PROGRAM INFORMATION BULLETIN NO. P09-01

SUBJECT: Potential Safety Hazard on J. H. Fletcher & Co. Roof Bolting Machines
with Independent Left and Right Tram Levers

Figure 1 (Tram Control Valve)

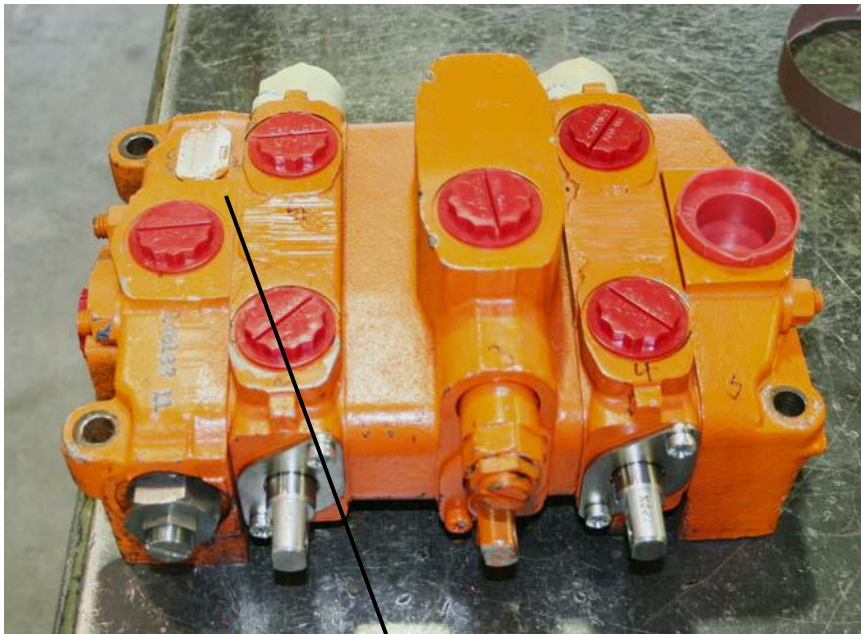
Machines that receive a **new tram control valve** can be identified as follows:

- 1: The part number on the tram control valve will be 148133-11 instead of 148133-00. Reference Figure 1 and Figure 2 below.
- 2: The date code in the serial number will be later than the population of suspect tram control valves (H0608-XXXX or later). Reference Figure 1 and Figure 2 below.

Will be "11"

Figure 3
(Tram Control Valve)

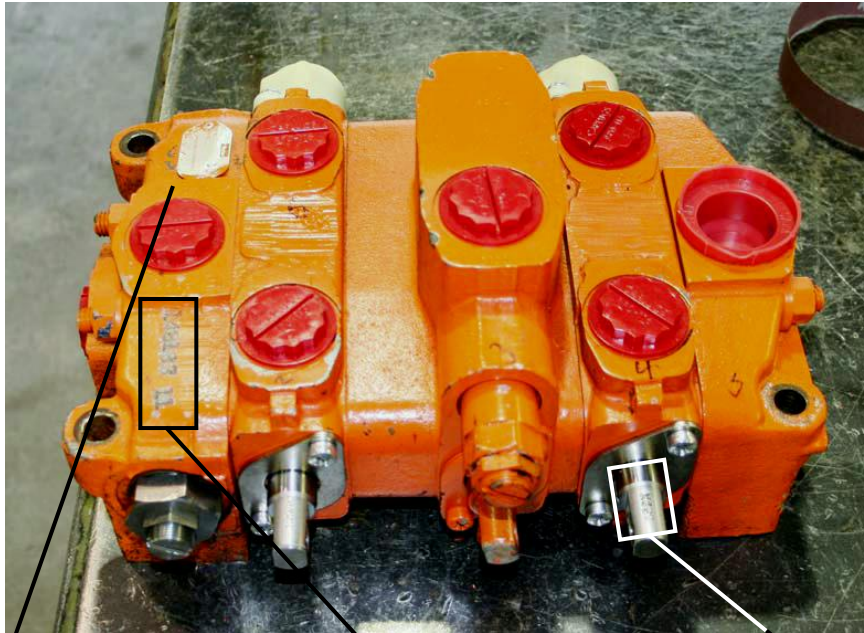
Machines that receive new tram control valve **spools** can be identified as follows:

- 1: The new part number "148133-11" will be stenciled on the tram control valve body. Reference Figure 3 and Figure 5 below.

- 2: If the original tram control valve tag is present, "11" will be stamped over the "00" at the end of the part number. Reference Figure 3 and Figure 4 below.
- 3: The new spools are stamped with "159X" on the handle end of the spool. Reference Figure 3 and Figure 6 below.
